Determination 2017/085

Regarding the authority’s decision to issue a code compliance certificate for alterations to a house at 36A Simla Crescent, Khandallah, Wellington

Figure 1: Approximate site plan

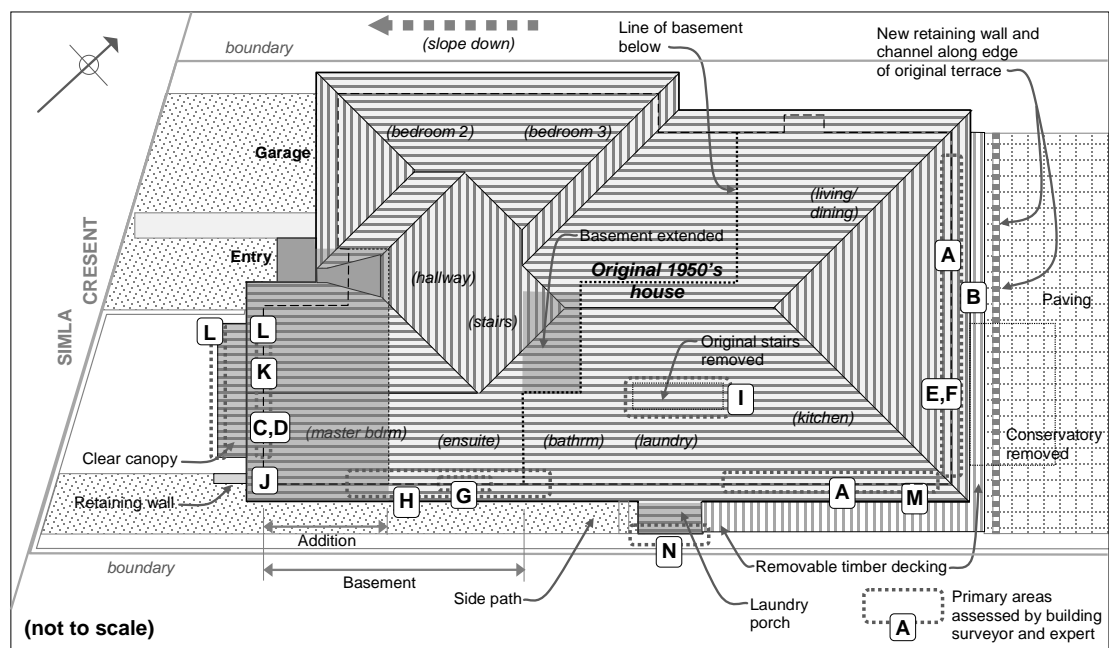
3.4.3 The building surveyor assessed the areas identified by the applicants. The following paragraphs outline defects considered likely to affect compliance with the building consent and/or the Building Code (with Areas A to N shown in Figure 1 in brackets) with comments in summary against each. Items not listed here were considered by the building surveyor to be cosmetic defects.

3.4.4 Items 6 to 9: Deck construction (Areas A and B)

- The deck construction does not accord with the consent details and some areas do not comply with Clauses B1, B2 and E2 of the Building Code.
- There are no joist hangers and the uncoated steel deck nails are corroding.
- The ribbon plate is fixed with stainless steel coach screws in lieu of the bolts detailed in the drawings, with some screws fixed only to weatherboards, and the junction lacks washers to prevent moisture ingress.
- Decking/weatherboard junctions lack 12mm drainage gap shown in drawings.

- Window head flashings/facings do not accord with drawings or E2/AS1⁶ (C).
- Head flashings prevent drainage from upper cavity and lack stop ends (D).
- Head flashings to northeast deck doors include lapped joints (E).
- Timber head facings lack drip edges (F).
- Sill flashing extends under planted timber sills in lieu of drawing detail (G).

- The bottom edge of weatherboards is unsupported and the lack of a packing strip provides a gap that may allow vermin to enter the drained cavity (J).
- The bottom edge of new weatherboards is unpainted, which may lead to deterioration. The cladding is required to achieve a durability of 15 years.
- The bottom edge of original timber weatherboards is sealed to the foundation wall, preventing moisture from draining from behind the cladding.
- The garden tap to southeast wall is not adequately sealed (M).

- No apron flashing is installed at the roof/wall junction (K).
- No brackets are installed to rafter ends as called for in drawings (L).

- No brackets are installed to post/beam junctions as called for in drawings (L)
- Brackets are needed to resist uplift in high winds.

- The omission of the specified brackets from the porch roofs (Areas I and K).
- The omission of joist hangers from the deck framing and the framing to the original stair opening (Area A).
- The replacement of bolts with coach screws to the deck ribbon plates (Area B).

- The lack of a drainage gap at the deck/wall junctions (A).
- The head flashings face-fixed to weatherboard, with no drainage gap from the upper cladding (C).
- Overlapped joints in head flashings over deck doors, unlikely to result in moisture penetration because door heads are well sheltered beneath the eaves (E).

- The head facings lacking drip edges as shown in the consent drawings, minor variation unlikely to result in moisture penetration (F).
- The lack of packing to the bottom of weatherboards, resulting in large gaps that can allow rodent access into the drained cavity (M).
- The unsealed exterior tap cladding penetration (J).
- The media room roof/wall junction lacks an apron flashing (K).
- An unsealed gap below the sill to the original southeast basement window.
- Movement of the projecting sill to the media room doors, indicating a lack of sill support (C).

6.3.2 Taking account of the expert's report I consider that compliance has either not been achieved, or has not been adequately demonstrated, in respect of the following clauses:

- the use of uncoated steel nails in the deck framing
- structural investigation and advice in regard to:
 - the lack of consented brackets to the canopy roofs
 - the lack of consented joist hangers to the deck framing
 - fixings to the infill framing to the original stair opening
 - the adequacy of the fixings, and replacement of bolts with coach screws to deck ribbon plates.

- the lack of a drainage gap at deck/wall junctions
- the lack of a drainage gap from the drained cavity above windows
- the lack of packing strips to weatherboards, with excessive gaps at bottom of cavities
- the unsealed exterior tap penetration through the weatherboards
- the unsealed gap under the original southeast basement window
- the movement to the projecting sill of the media room doors.
